APPLICATION FOR SUBMITTAL OF POST-APPROVAL DOCUMENT

2. PROJECT INFORMATION:			
School District/Owner: Lodi Unified School District		DSA File Number: 39 H4	
Project Name/School: Lodi High School Breezeway Repair		DSA Application Number 02 121377

CCD NO. 01 NARRATIVE

School District/Owner: **Lodi Unified School District**
Project Name/School: **Lodi High School**
DSA File/Appl No.: **39-H4 /02-121377**
CCD Number: **#01**

CEILING FRAMING DETAILS

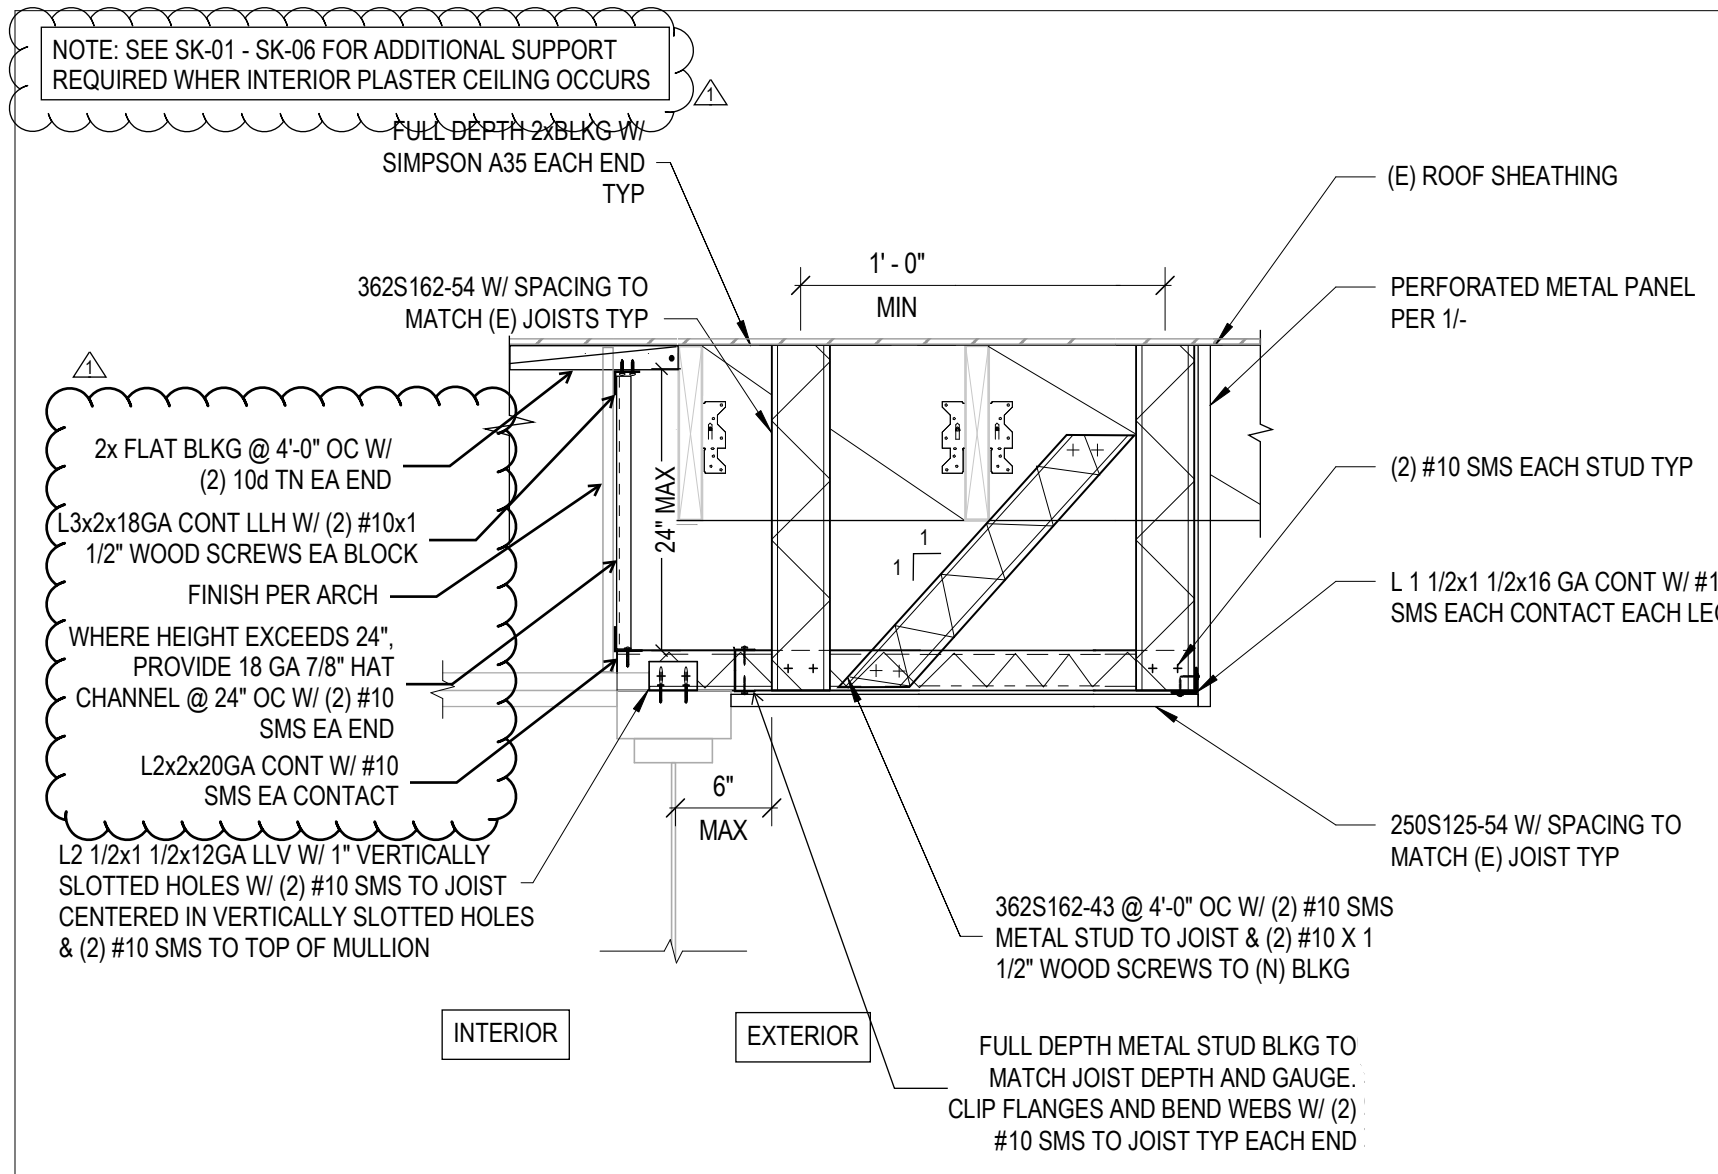
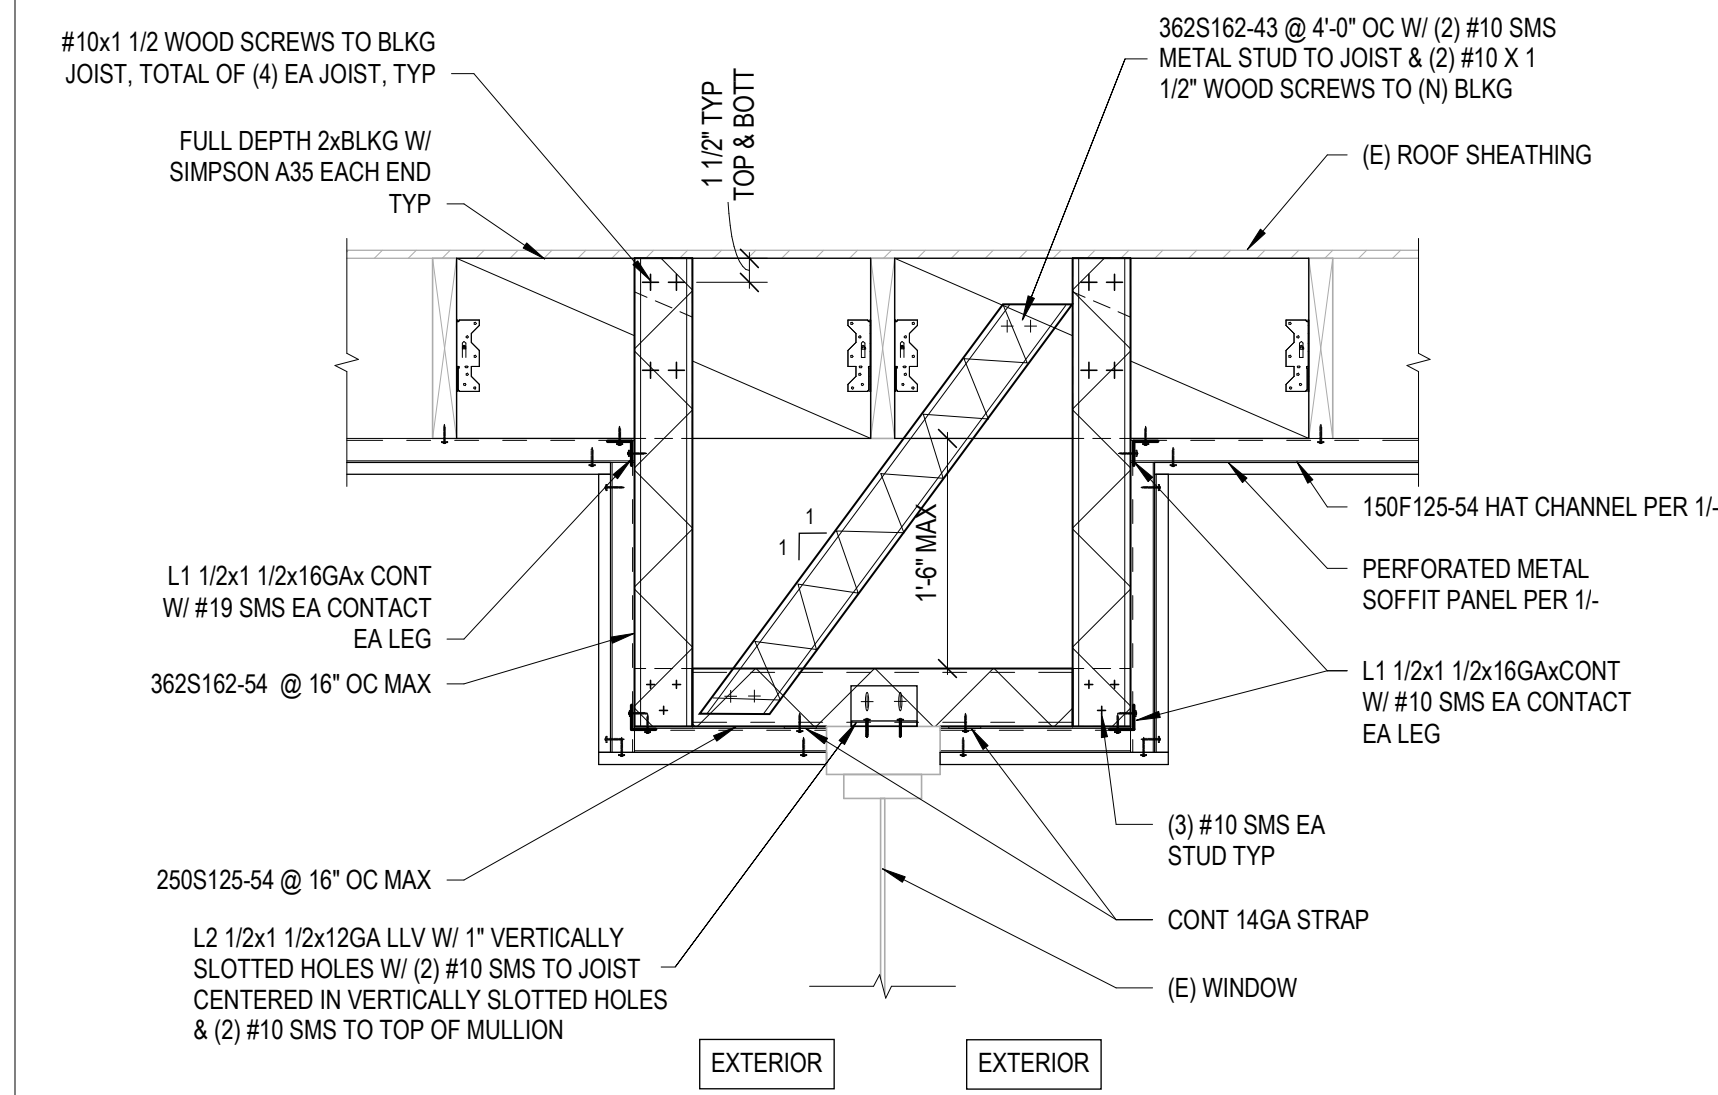
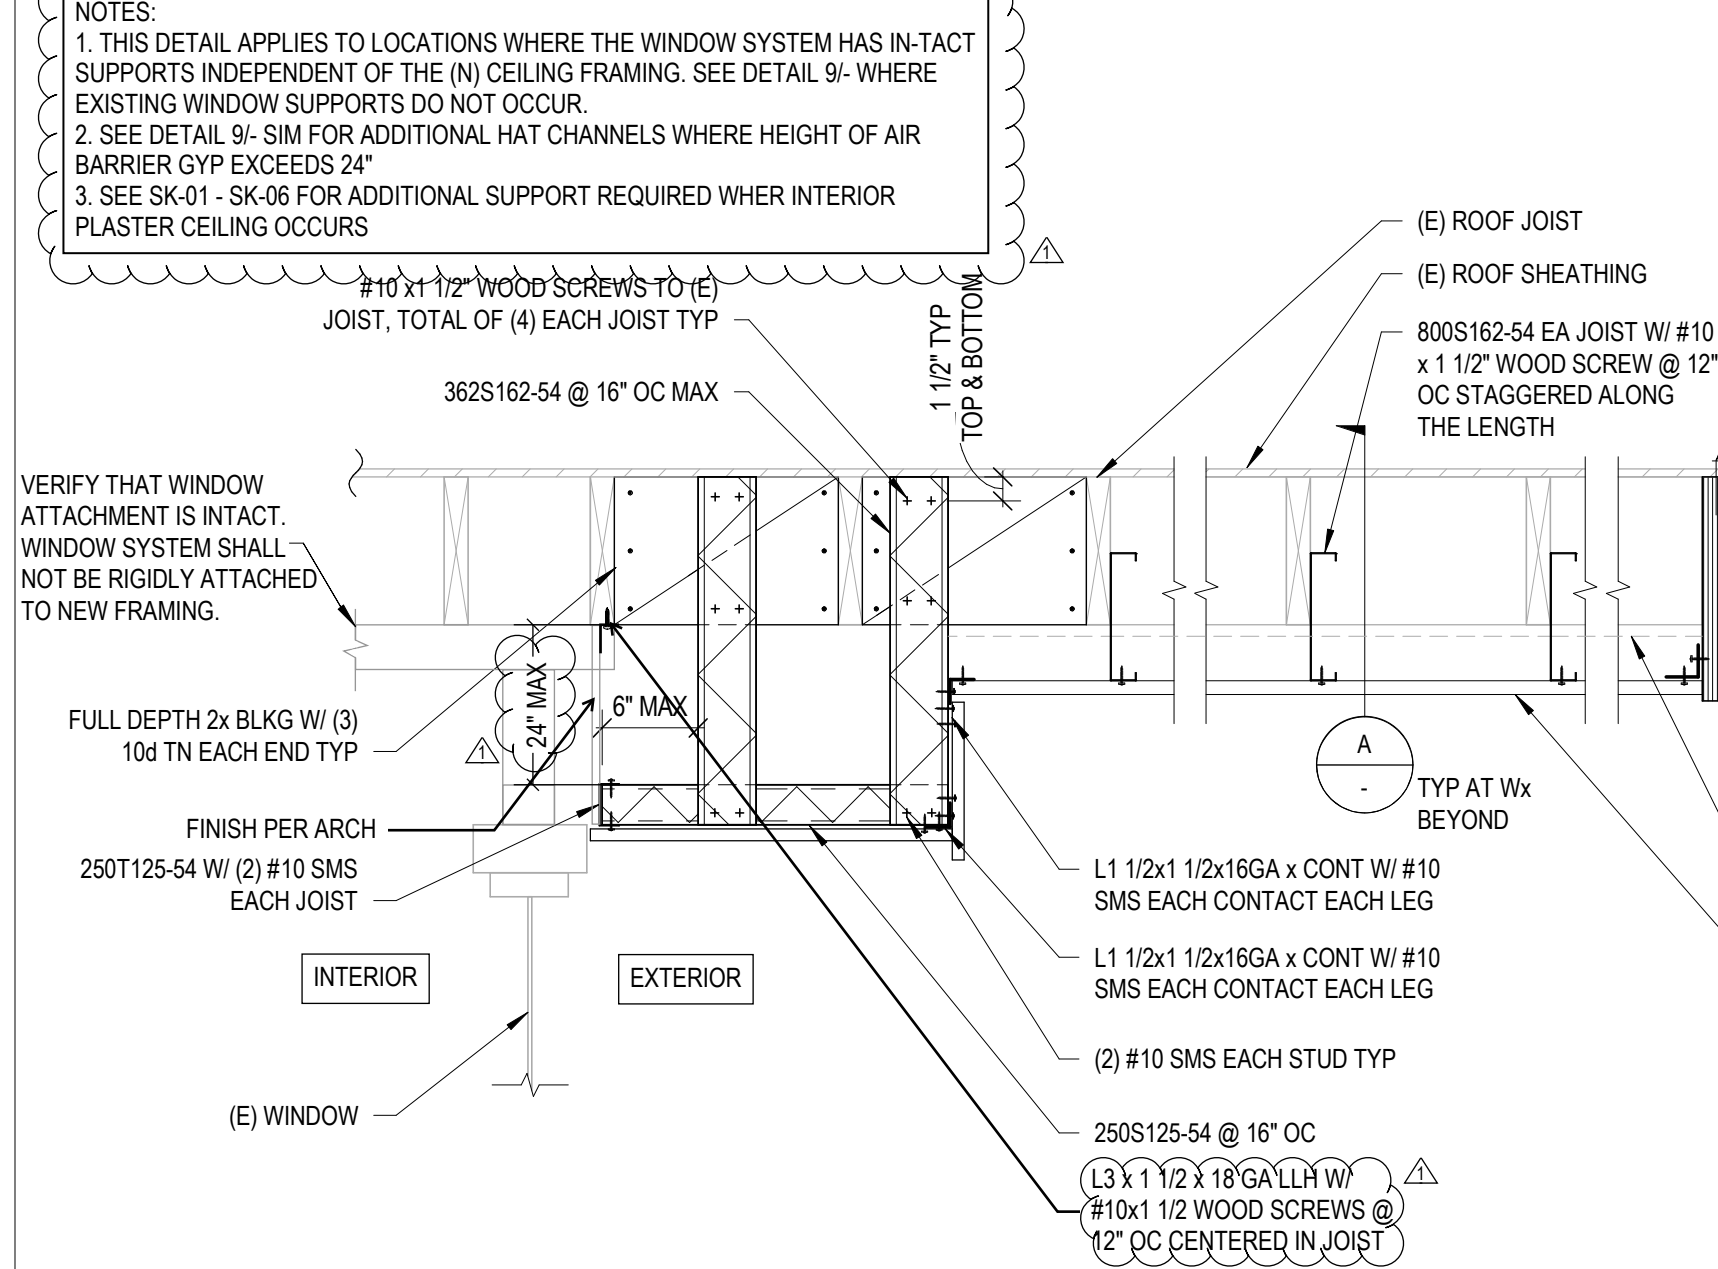
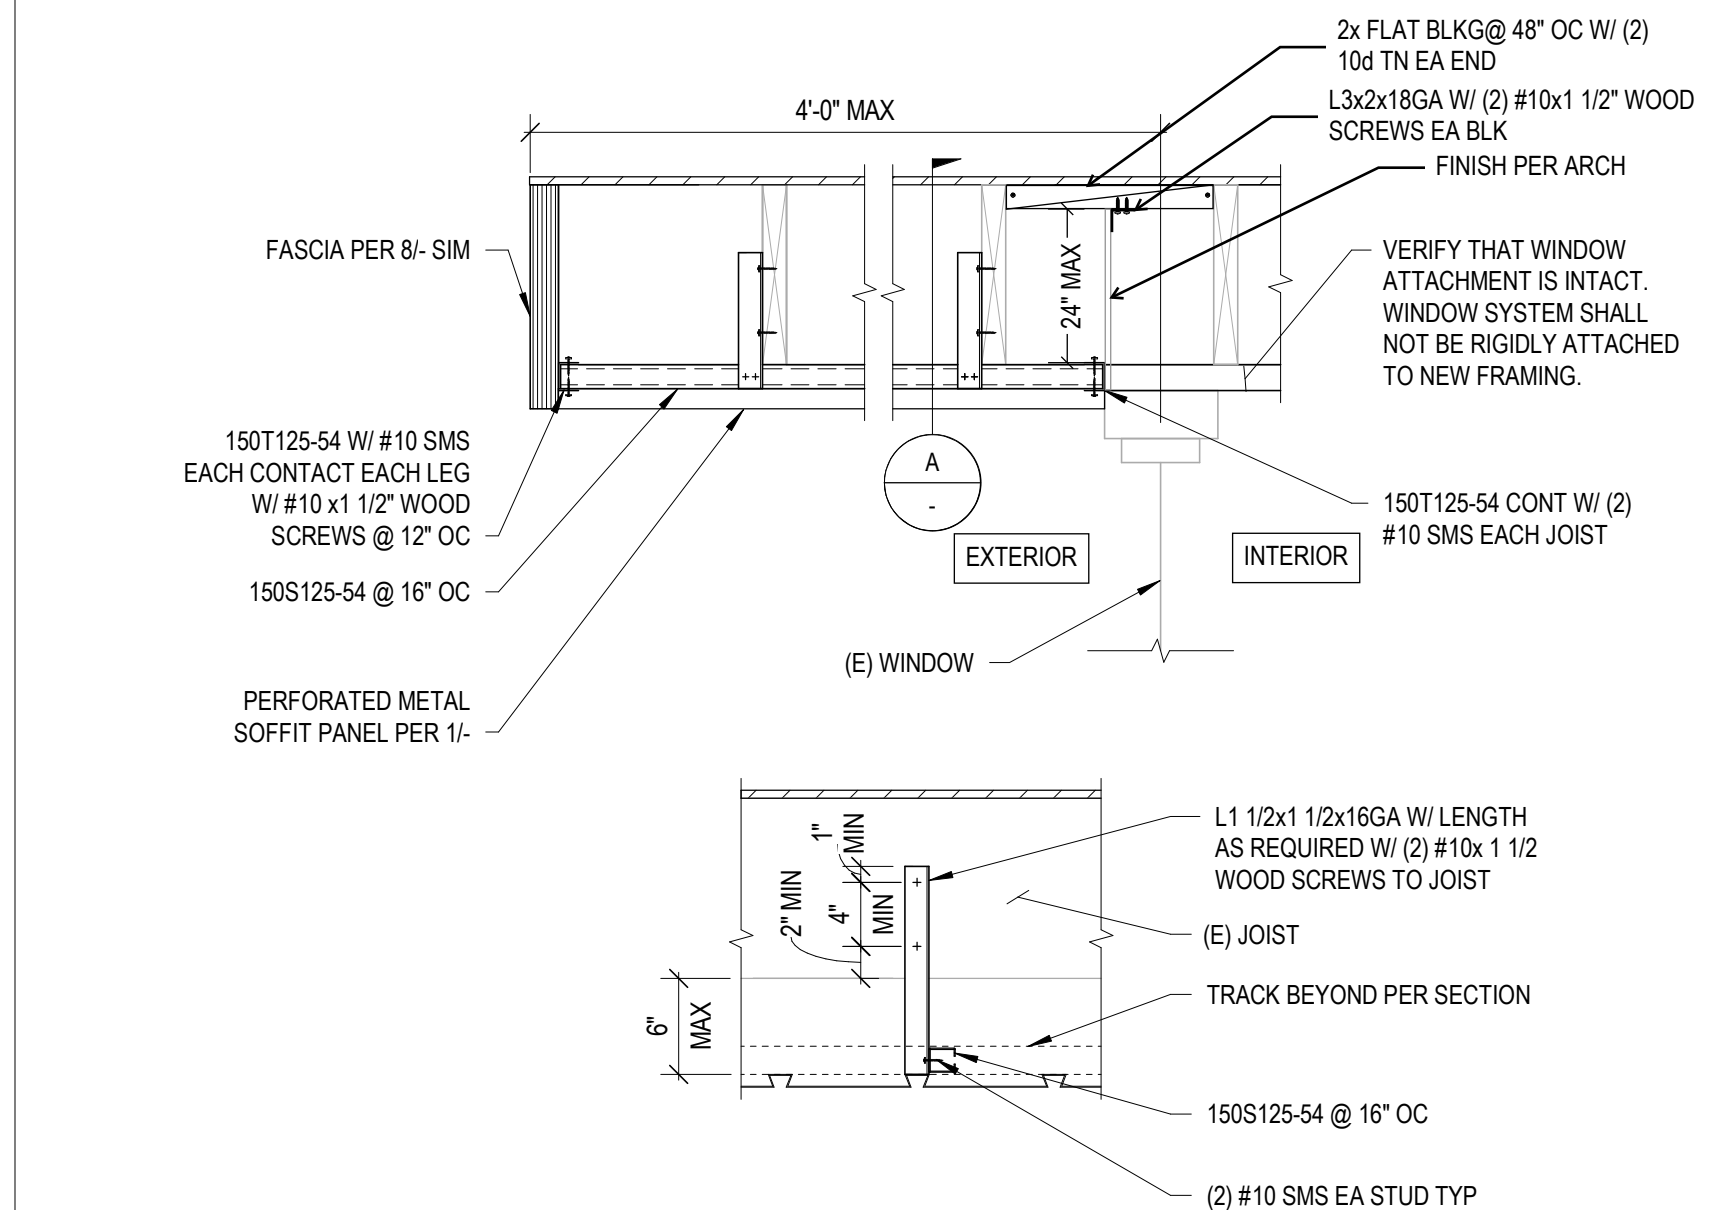
Details on sheet S2.1 have been revised to reflect new non-structural framing required to support an air barrier above windows. Additionally, sketches SK-01 – SK-06 have been included to show new support framing required for the currently unsupported section of plaster at the interior edge of the existing window systems.
